Falmouth Docks Development: Appropriate Assessment Addendum – Fal and Helford SAC

Project name **Falmouth Docks Development**
Project no. **1620015743-006**
Client **A&P Group**

Date 13/10/2025

Figure 14 - Location 3 showing SSC time-series for dredging in west (top), north (middle) and east (bottom) over a 2-week spring-neaps tidal cycle

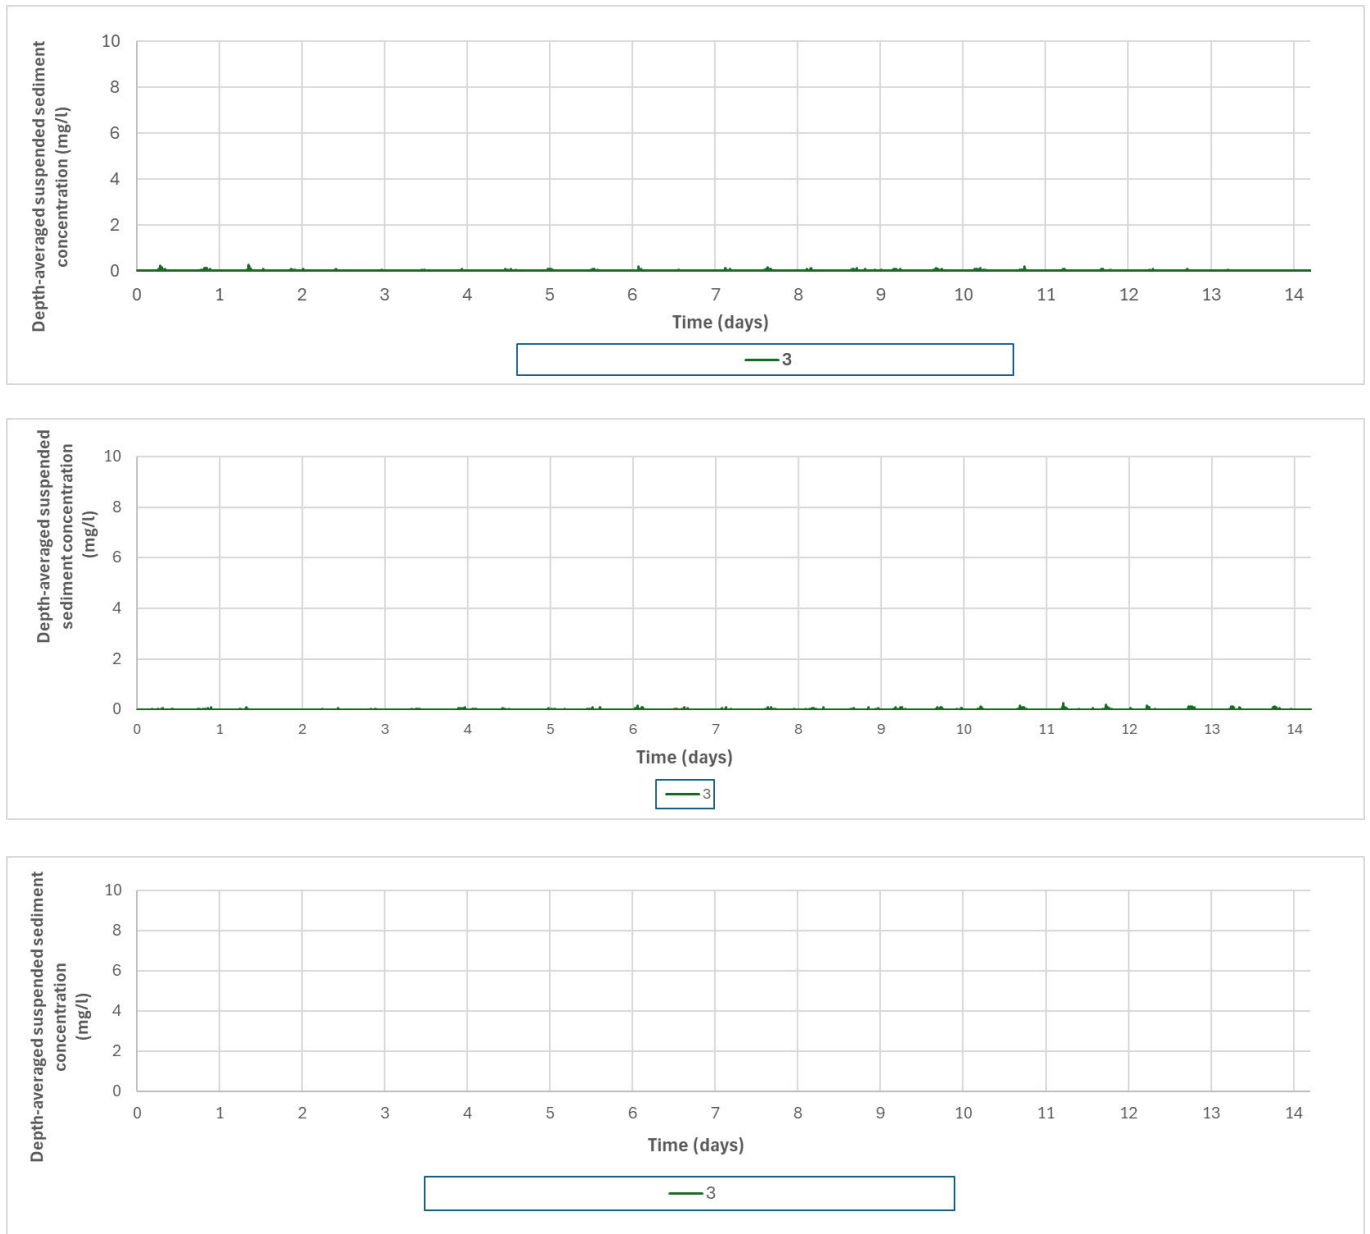
Site 3, within the area of maerl that was mapped as 'live maerl over dead maerl' also has a very low increase in SSC across the whole tidal cycle, indicative of the effectiveness of the tidal restriction mitigation measure (Figure 14).

Figure 15 – Location 5 showing SSC time-series for dredging in west (top), north (middle) and east (bottom) over a 2-week spring-neaps tidal cycle

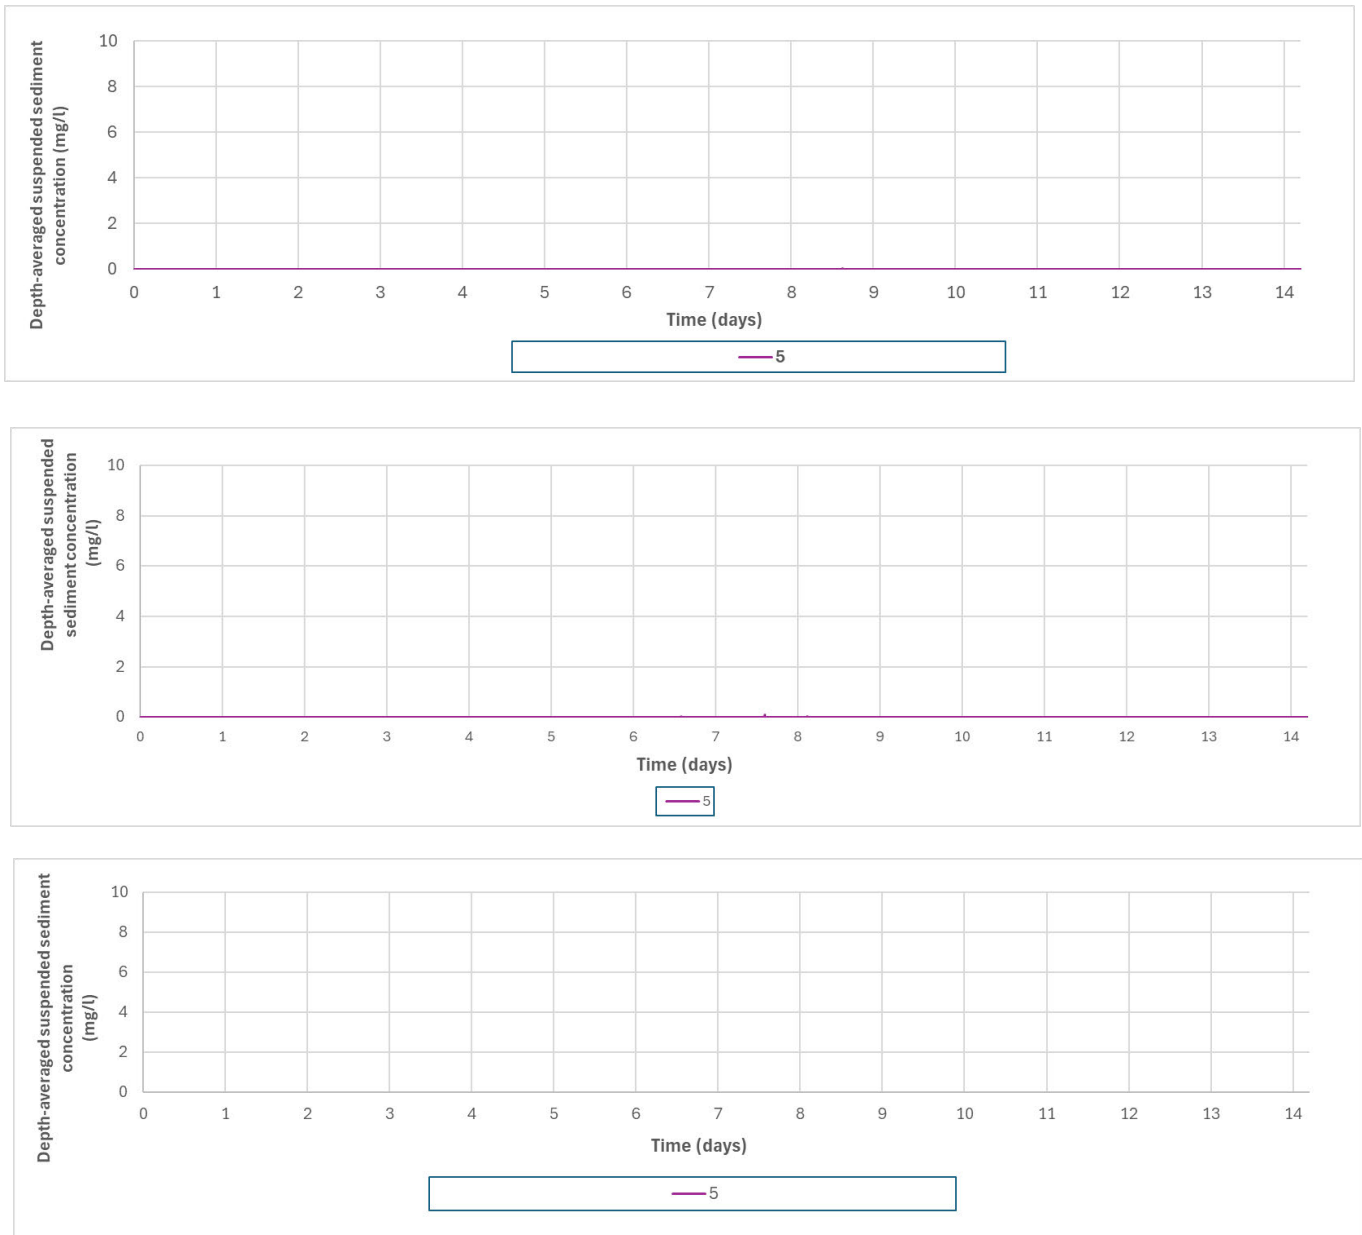
At Site 5 the maximum SSC was <0.1 mg/l, including from dredging in the north area (Figure 15), and thus the seagrass beds at Flushing were beyond the ZOI for SSC and no further assessment of this habitat is required.

Figure 16 - Sediment deposition (mm) overlay on maerl habitat classification at the end of the entire dredging campaign as a result of proposed dredging operations (Carcinus Ltd, 2025)

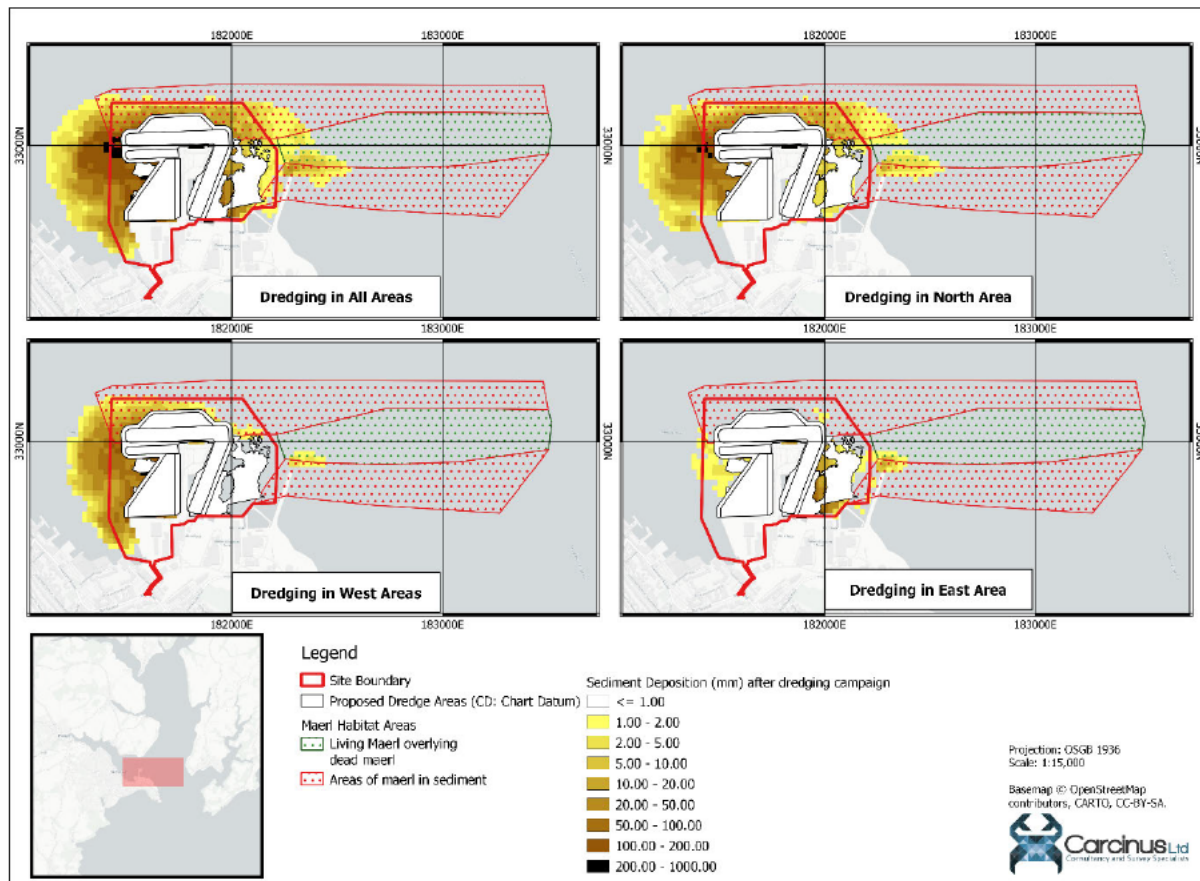
Deposition modelling following dredge activities, when overlaid as contour plots on maerl habitat mapping demonstrates that the area of deposition is largely constrained to the red line boundary, with a very limited spatial ZOI (Figure 16).

The area of deposition outside the eastern site boundary, extends to areas mapped as live maerl over dead maerl. The maximum deposition value within this habitat of 18.4 mm sediment depth was extracted from the contour plot. The higher values reported, of 50 mm, were also based on contour plot data, predicted for a localised area at the end of the Eastern Breakwater. This is outside the area with live maerl, instead within the habitat mapped as maerl in sediment but identified as dead maerl with a 2D structure (see Figure 6). HR Wallingford have estimated the area of total deposition predicted by the modelling within the areas mapped as live maerl overlying dead maerl. Approximately 1.38 ha of this area is modelled as having a total deposition of 1-2 mm; approximately 0.96 ha is modelled as having a total deposition of 2-5 mm; approximately 0.71 ha is modelled as having a total deposition of 5-10 mm; and approximately 0.04 ha is modelled as having a total deposition of 10-20 mm.

Figure 17 - Predicted time-averaged concentration of Tributyl tin (TBT) over 15 days of dredging

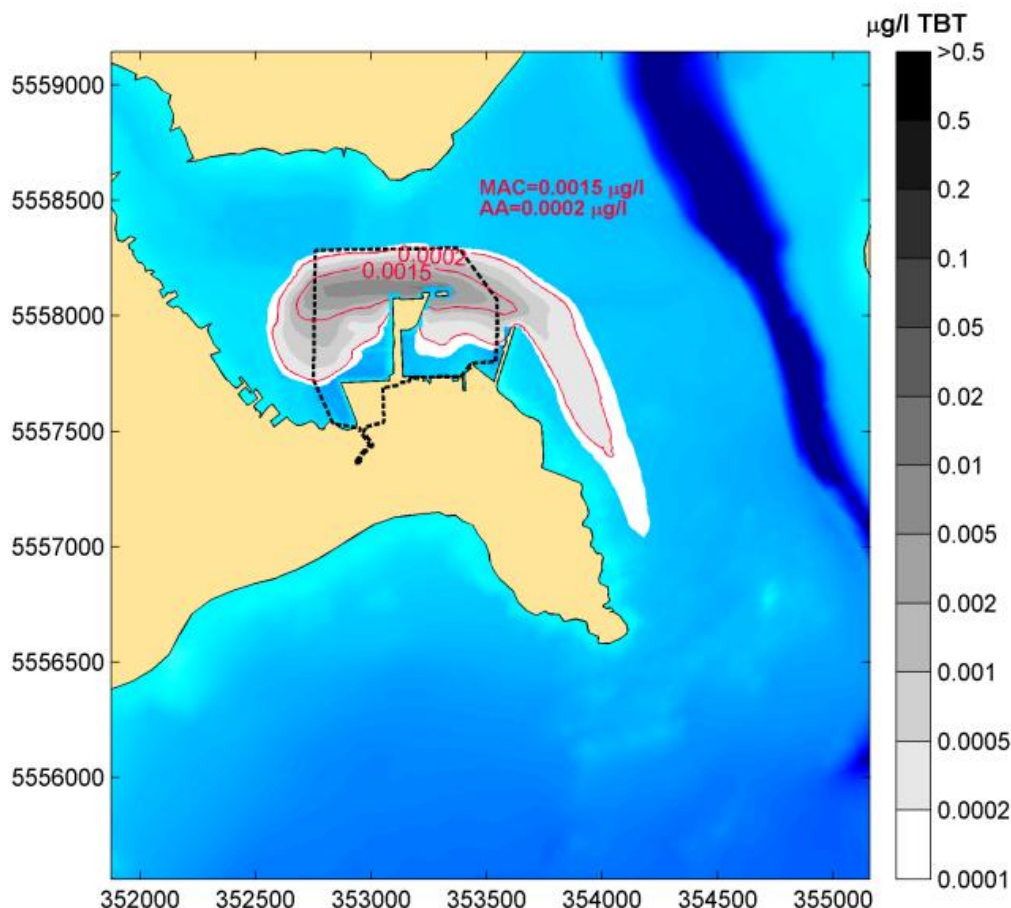
When reviewing specific contaminants that would be released as part of the proposed dredge activity, TBT is the only contaminant released into the aqueous phase that was modelled to be present in concentrations above EQS standards (Figure 17). Note, the modelling undertaken was for the unmitigated scenario only, with dredging during any tidal condition.

However, as stated in the HRA Report, the inclusion of the tidal mitigation for dredge activities is predicted to halve the concentration of TBT in aqueous phase. The concentration of the predicted 'finger' of aqueous contamination extending southeast of the site boundary would be halved and if remapped would be significantly reduced in extent.

Thus, the proposed mitigation also constrains the ZOI in relation to contamination of TBT in the water column to be largely contained within the red line boundary. Cefas have reviewed the ES and the Technical Appendices and were satisfied with the approach taken and conclusions of no significant impacts to benthic features.
